RE: EIS Addendum Report - Audrey Meadows Ltd. - Part Lots 17, 18, and 19, Concession 8, **Township of Puslinch**

Stovel and Associates Inc. ("SAI") and Lincoln Environmental Consultants Inc. ("LEC") were retained by Audrey Meadows Ltd. to prepare an Environmental Impact Study ("EIS") for a proposed development. The Township of Puslinch retained Natural Resource Solutions Inc. ("NRSI") to peer review the EIS. NRSI's letter (dated August 04, 2021) sets out several questions/concerns. The purpose of this letter is to address the comments of NRSI.

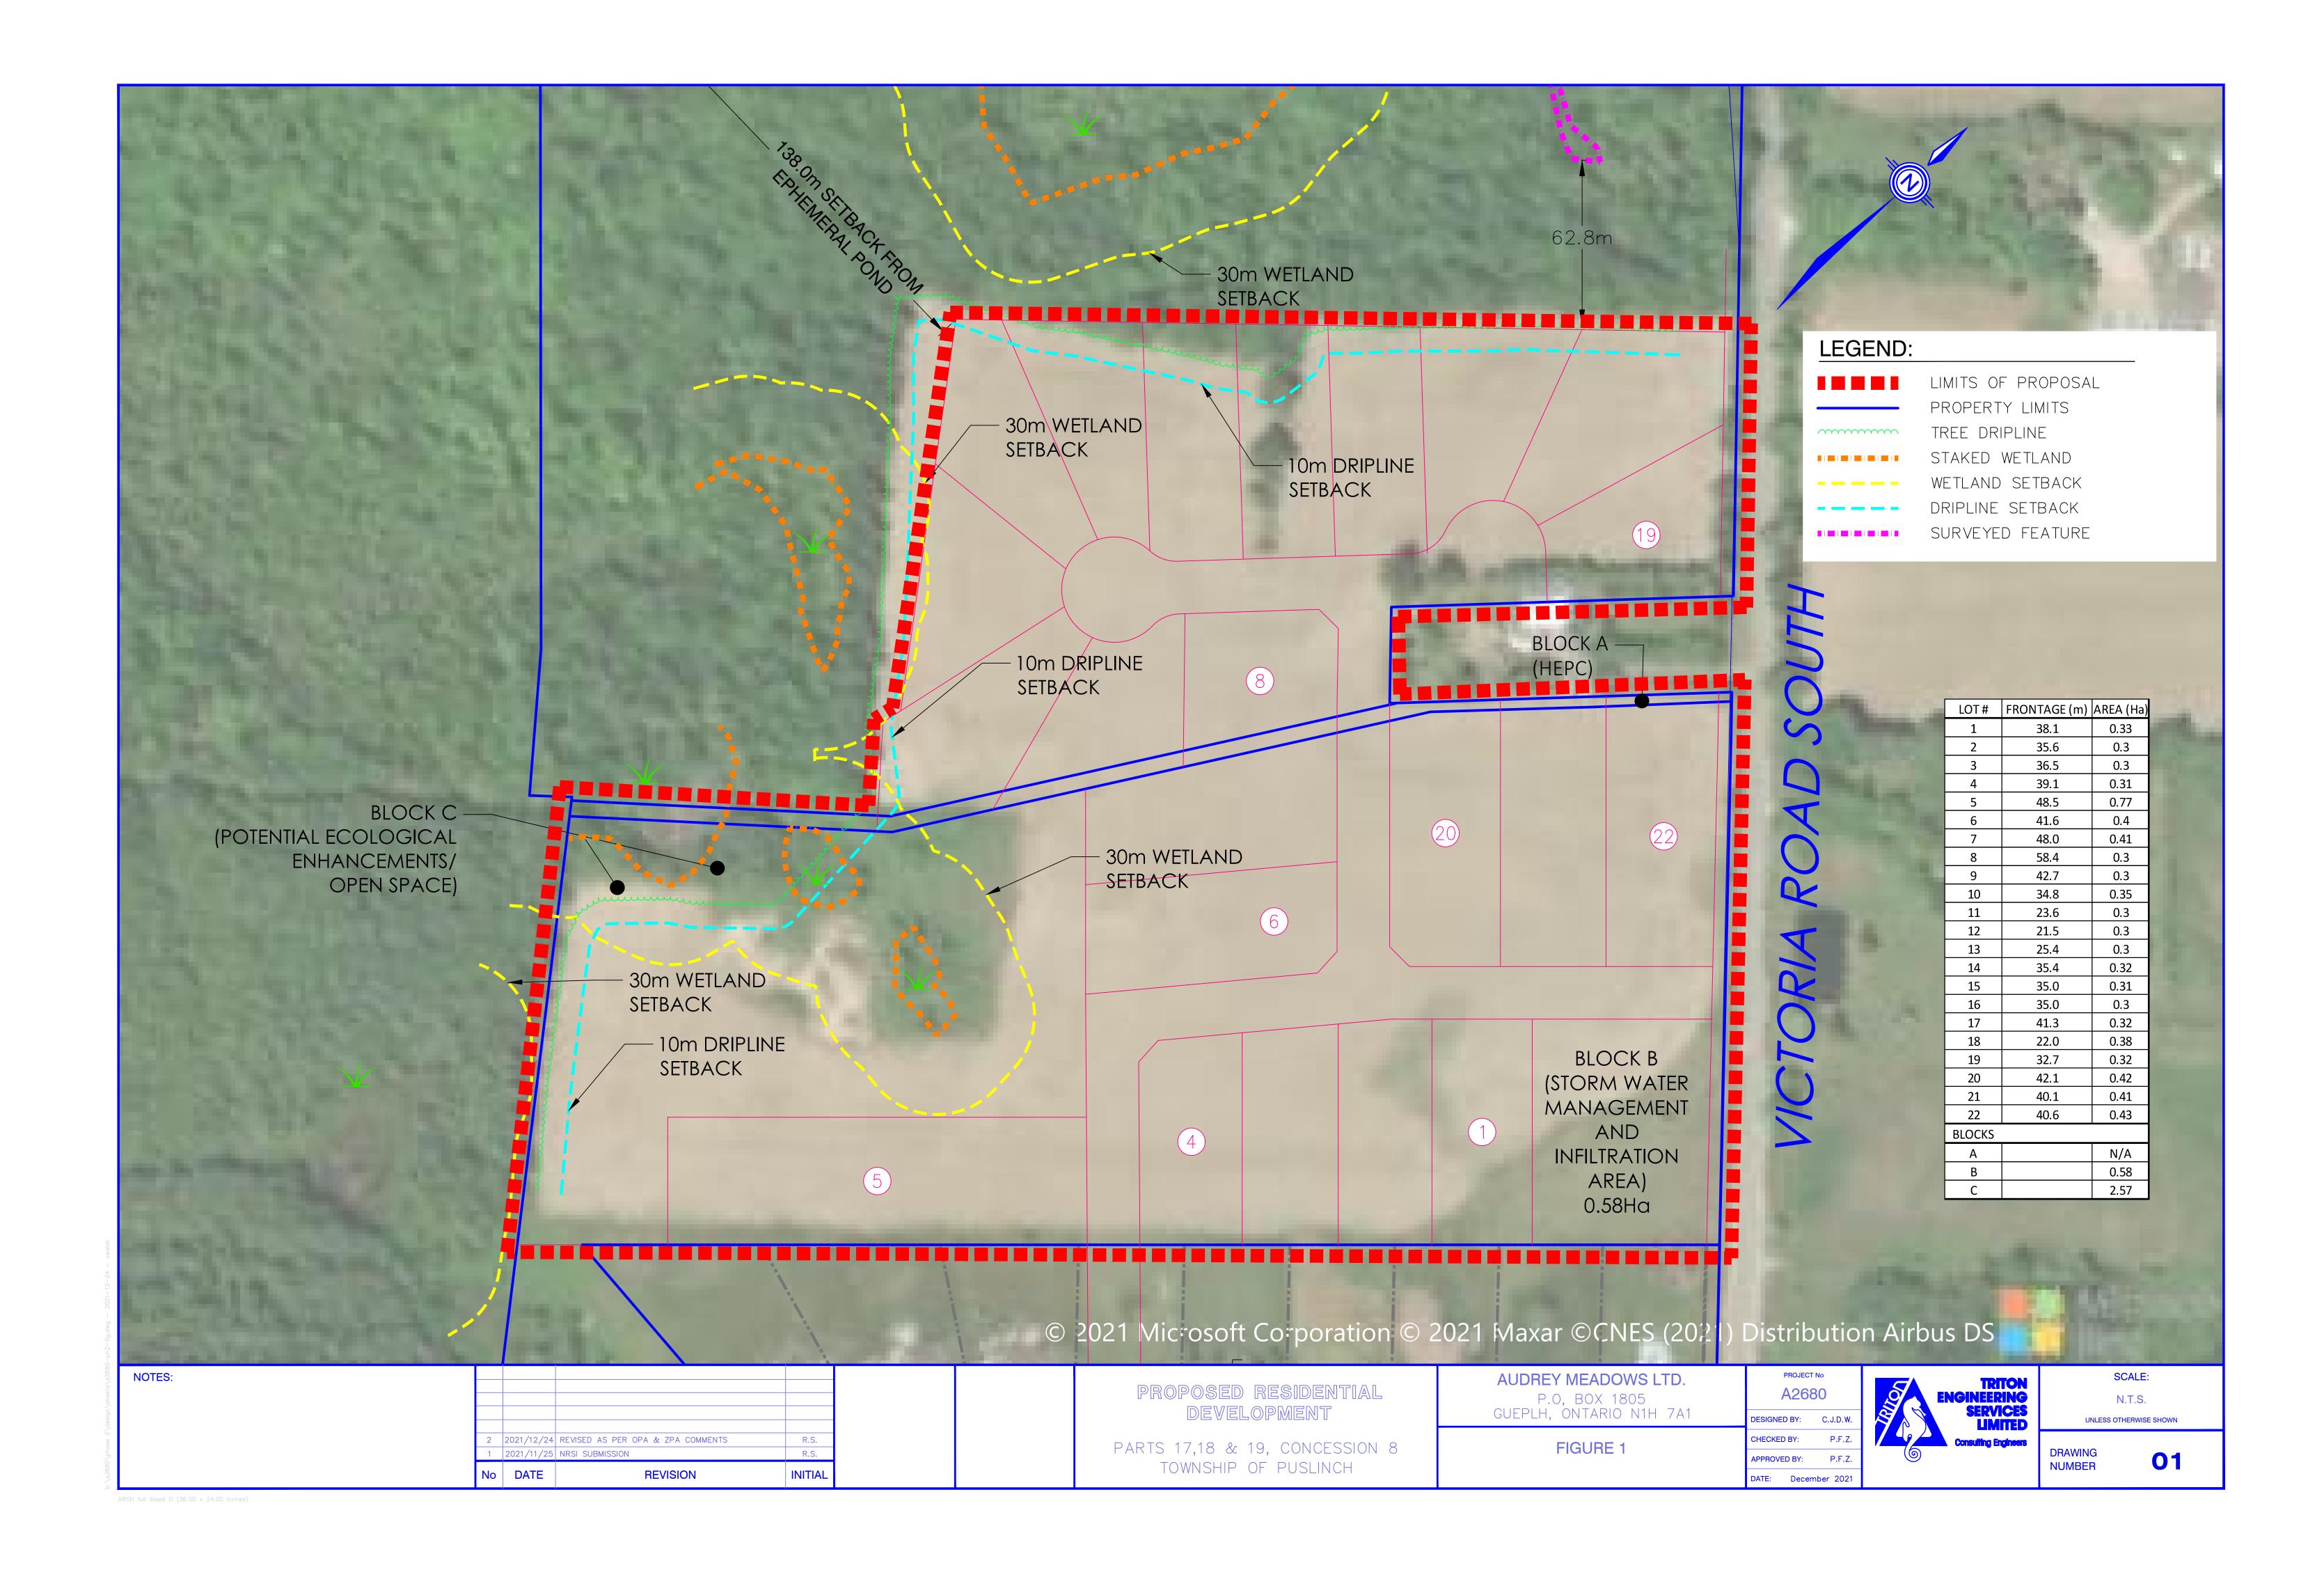
In addition, Audrey Meadows Ltd. has requested its engineers, Triton Engineering Services Limited ("Triton") to prepare a revision to the development concept (Drawing 01), resulting in a reduction of the number of lots to 22 (from 29). This revised development concept illustrates that the rear lot lines have been pulled back to the edge of the farm field and minimum rear vard setbacks have been established to protect the forest edge (i.e., 10 m from the dripline). All development proposed in this development concept will remain over 30 m from any wetland limit.

The wetland boundaries have been flagged, confirmed with the Grand River Conservation Authority ("GRCA") and surveyed by Triton. Drawing 01 illustrates the proposed development concept showing the revised lot fabric and the relevant environmental setbacks. Two additional features were surveyed and referenced on Drawing 01: a) stone pile next to a parking area in the bush which is approximately 62.8 m from the north of the proposed development; and b) an ephemeral pond in the woodland which is approximately 137 m from the proposed development.
